Service Letter

Service Bulletin No. SL TMG 000-1004, Initial Issue
Date: May 24, 2017

Subject: Improper fixation on steel pipes

Figure 1 affected area

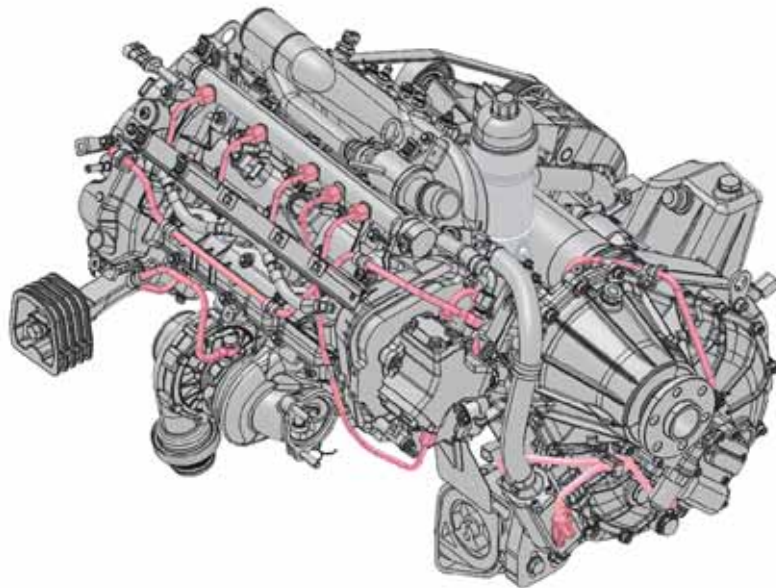
Reason: Maintenance problems were discovered due to improper fixation on steel pipes. This could lead to a breakage of a steel pipe and/or connection followed by a power loss or IFSD.

Correction: Improper fixation on steel pipes must be corrected.
The following figures show examples of improper fixations.

Figure 4 non-approved attachment: rail pressure pipe

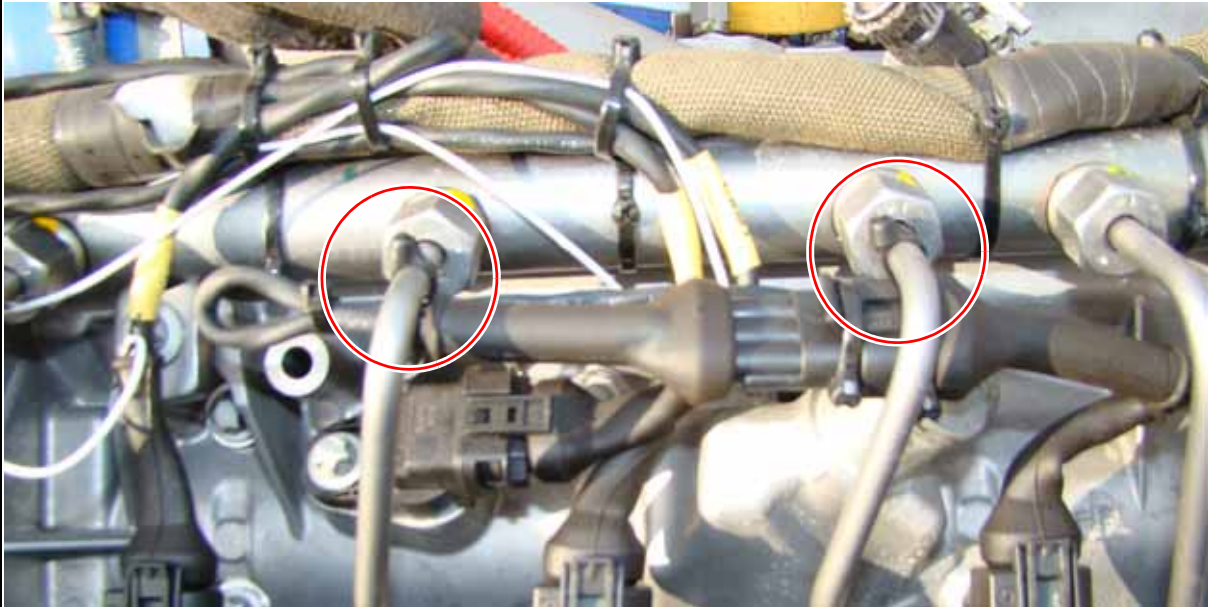
Incorrect
